Title of Change:	Change of connector on the ArrayJ-60035-4P-PCB
Proposed First Ship date:	31 Jul 2022 or earlier if approved by customer
Contact Information:	Contact your local onsemi Sales Office or Deborah.Herbert@onsemi.com
PCN Samples Contact:	Contact your local onsemi Sales Office. Sample requests are to be submitted no later than 30 days from the date of first notification, Initial PCN or Final PCN, for this change. Samples delivery timing will be subject to request date, sample quantity and special customer packing/label requirements.
Additional Reliability Data:	Contact your local onsemi Sales Office or Ricky.Garcia@onsemi.com
Type of Notification:	This is a Final Product/Process Change Notification (FPCN) sent to customers. FPCNs are issued 90 days prior to implementation of the change. onsemi will consider this change accepted, unless an inquiry is made in writing within 30 days of delivery of this notice. To do so, contact PCN.Support@onsemi.com

Final Product/Process Change Notification

Document #:FPCN24558X

Figure 1 – Old 8-pin DIP connector

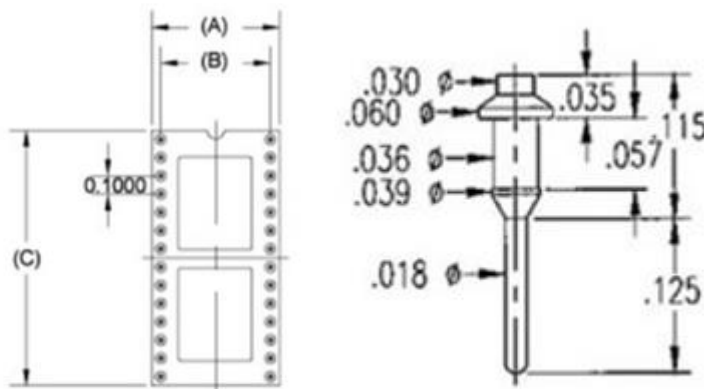
This document describes the change of connector that has been implemented to improve the robustness and reliability of the product. Both the old and new connectors are an 8-pin DIP header with 0.3" width, and the same socket can be used for both. Pin assignment remains the same.

Note also that no changes have been made to the sensors, sensor layout, performance, or footprint of the PCB. The diagrams below show the old connector (Figure 1 and Table 1) and the new connector (Figure 2).
